NUCLEAR DIRECTORATE

GENERIC DESIGN ASSESSMENT – NEW CIVIL REACTOR BUILD

STEP 3 STRUCTURAL INTEGRITY ASSESSMENT OF THE EDF and AREVA UK EPR

DIVISION 6 ASSESSMENT REPORT NO. AR 09/012-P

Figure 1

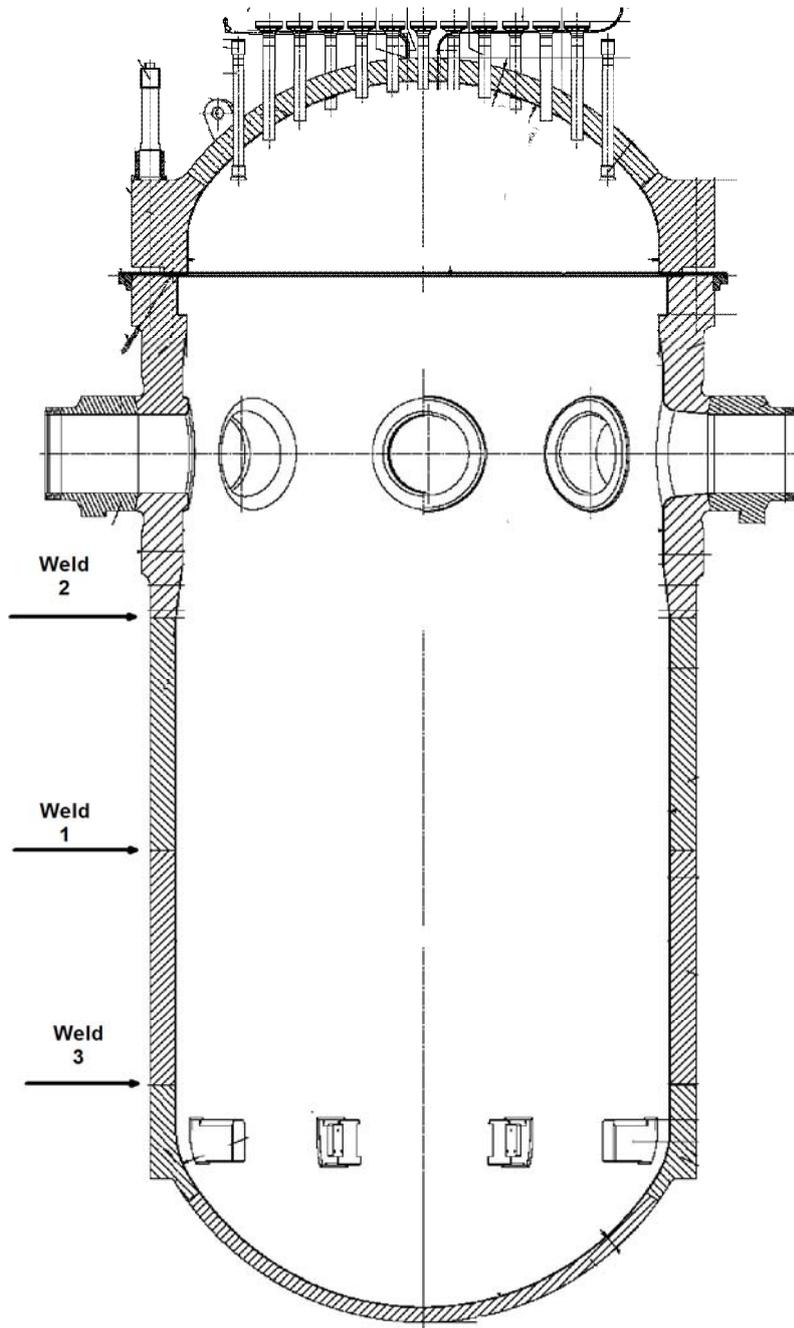
- 203 Para. 262 of the SAPs (Ref. 7) item (c) states that designs should consider avoiding welds in high neutron radiation locations.
- 204 Figure 1 here shows the locations of three circumferential welds in the body of the EPR Reactor Pressure Vessel, adjacent to the core. As designated here, Weld 1 is at the core mid-height, Weld 2 is just above the top of the core and Weld 3 is just below the bottom of the core.

- 205 At first sight, Weld 1 at core mid-height could be an issue, it is at the location of highest neutron irradiation. However the EPR core design includes a heavy reflector situated around the outside of the core, but within the core barrel (UK EPR PCRS Ref. 6, Sub-Chapter 3.4 section 6.4.2 and Figure 3.4.6-4). The reflector consists of a stack of twelve massive perforated slabs. The perforations allow cooling water flow through the reflector. This structure reflects neutrons back into the core (and will absorb some) so that the neutron flux exiting the outer surface of the core barrel is significantly reduced, compared with no reflector.

1. Whether it is possible to procure a single cylindrical forging spanning between Welds 2 and 3 in Figure 1, so avoiding Weld 1. EDF and AREVA added information to the June 2009 edition of the PCSR (Ref. 6, Sub-Chapter 5.3 Section 3.1.3) which supports the claim that worldwide, present forging technology is unable to produce a single cylindrical forging of the required diameter, height and thickness. I find the information supporting this claim to be convincing. In addition, as noted above, the neutron dose to Weld 3 is only slightly less than for Weld 1 and even if a single cylindrical forging was possible, it would not completely eliminate the issue of neutron irradiation of welds. I note too that the PCSR claims that in French PWRs, end of life transition temperature shift is greatest for the base metal, not the welds. I regard the question of the presence of Weld 1 in the design as closed.

- 226 Ref. 19 expresses some concern that for Welds 2 and 3 in Figure 1, the base material below Weld 3 and above Weld 2 is not subject to the same chemical composition restrictions as the cylindrical forgings that are joined by Weld 1. This is a reasonable concern based on the RCC-M Part Procurement Specifications. However, recently EDF and AREVA have sent ND a copy of the equipment specification for an EPR RPV (Ref. 37). This equipment specification clearly shows the following requirements in terms of Copper content:

- Copper \leq 0.08% for core shells, transition ring, flange / nozzle shell;
Copper \leq 0.1% for lower head, nozzles, head flange, upper head.
- 227 The limit of 0.08% for the transition ring and flange / nozzle shell is an additional restriction compared with the RCC-M Part Procurement Specifications. It means that Welds 2 and 3 in Figure 1 have base forgings on both sides with Copper content limited to \leq 0.08%. I believe this addresses the concern expressed on this matter in Ref. 19.

Figure 2

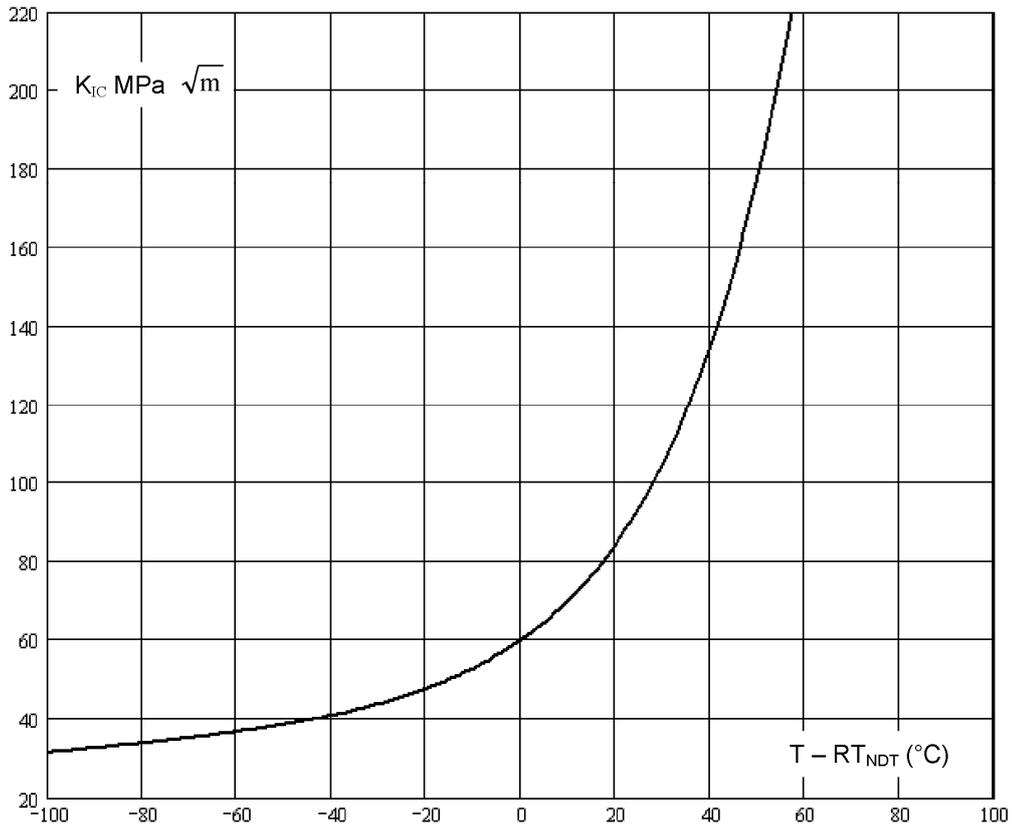
- 215 An example of how one measure of fracture toughness (K_{Ic}) changes with temperature is shown in Figure 2. This curve would be expected to be a lower bound to actual test data. The temperature axis is indexed to RT_{NDT} .

Figure 3

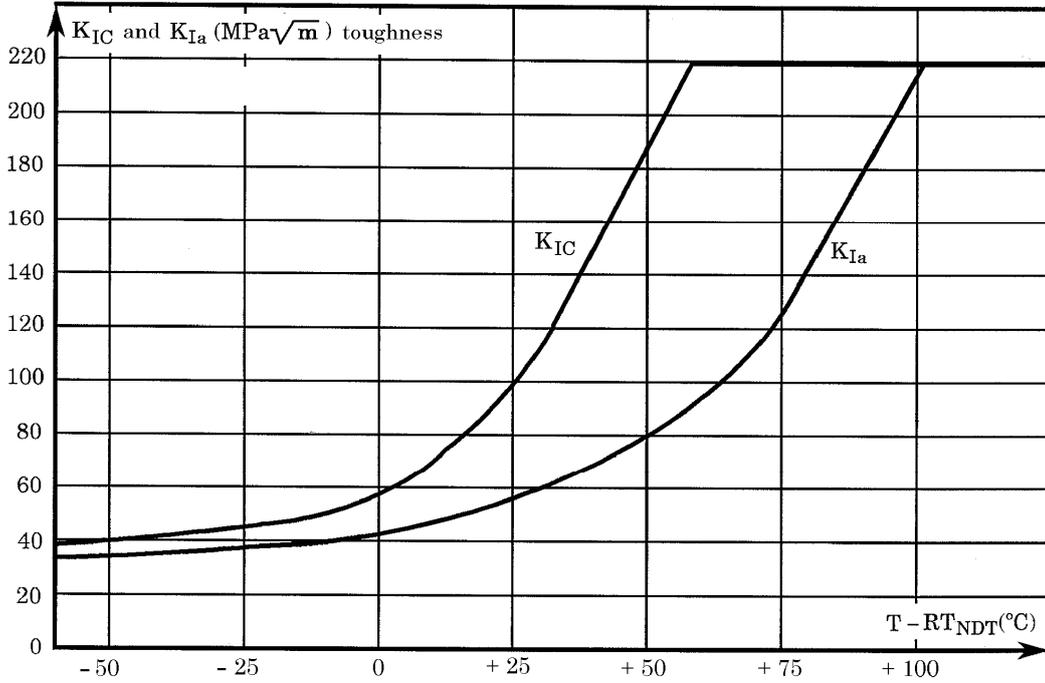
- the following inequality is satisfied $2K_{Im} + K_{It} \leq K_{IR}$, where K_{IR} is the material reference toughness curve.
- 257 The K_{IR} curve is the same as the K_{Ia} curve which is a lower bound to crack arrest toughness data. See Figure 3 here.

- 260 However, using the footnote in the 2007 edition, the method appears generally similar to the RCC-M 2005 edition, except for the use of K_{Ic} rather than K_{Ia} . The implications of this change can be seen in Figure 3; the Pressure-Temperature limit curve could move to lower temperature on the basis of using K_{Ic} rather than K_{Ia} .

- 261 Although there may be technical arguments to support this change, all other things remaining equal it will result in a reduction of margins. This change is not unique to the
